32-Lead Very Thin Plastic Quad Flat, No Lead Package (RTB) - 5x5 mm Body [VQFN] With 3.6x3.6 mm Exposed Pad and Stepped Wettable Flanks

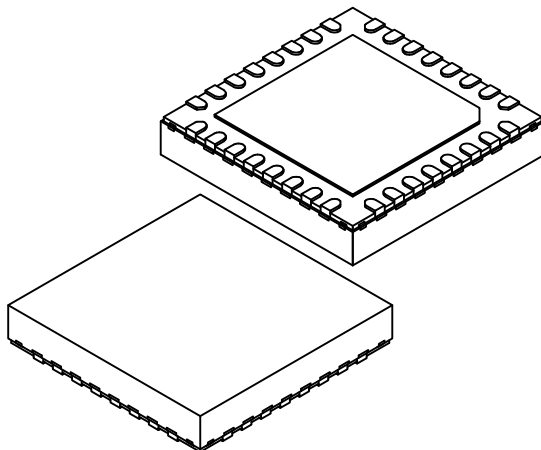
Dimensions D3 and A4 above apply to all new products released after November 1, and all products shipped after January 1, 2019, and supersede dimensions D3 and A4 below.

No physical changes are being made to any package; this update is to align cosmetic and tolerance variations from existing suppliers.

Wettable Flank Step Length	D3	0.035	0.06	0.085
Wettable Flank Step Height	A4	0.10	-	0.19
